Land Development Comments - Variance Lithonia ISP

PROJECT: ALPHARETTA PROPOCO
 SHEET: C11.8

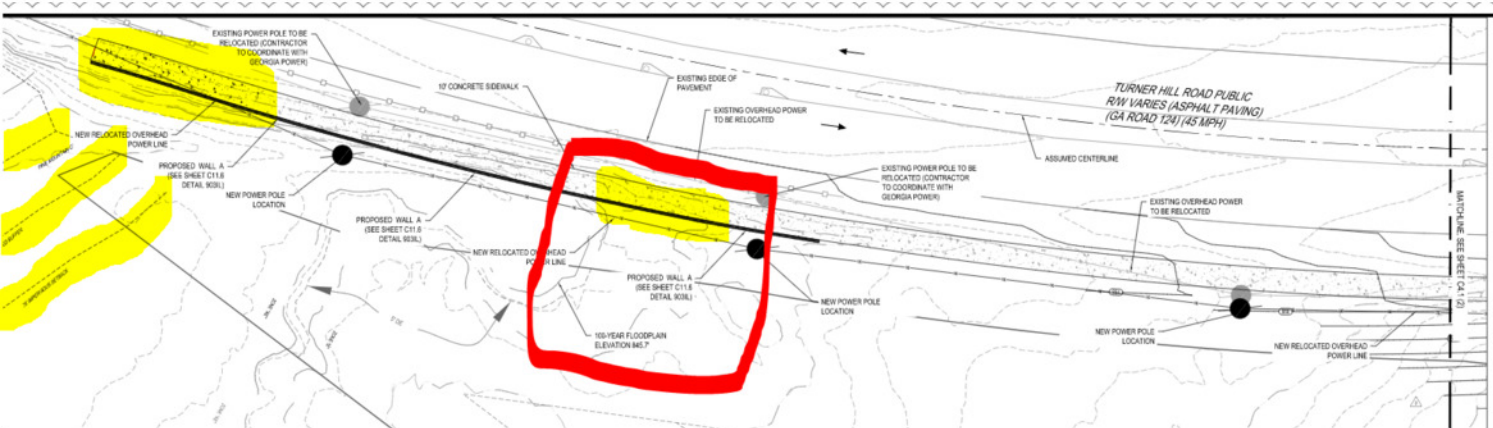
The Land Development section doesn't support this variance request:

See the area highlighted in yellow on the attached screenshot. The County codes will support a stream buffer variance request for the 50 ft county buffer. Also, instead of a concrete sidewalk, the County can allow to build that section of the sidewalk as a trail with pervious materials which will reduce the disturbance in the buffers (this will be also acceptable to the EPD for the 25 ft state stream buffer). Also, if the EPD doesn't grant a variance for the 25 ft state stream buffer; the applicant/developer can end the sidewalk by that 25 ft buffer line.

Additionally, towards the end of the property, there is there is portion of the sidewalk where the wall (which is proposed to support the sidewalk) is encroaching into a floodplain area (see the area highlighted in yellow with the red square on the screenshot below)

However, the driveway can be re-routed in such a way that it doesn't encroach into the floodplain. Only a small portion of the wall is encroaching into the floodplain. Also, the Land Development section will accept and the County, instead of a no sidewalk option, may allow the width of the sidewalk to be reduced in that section.
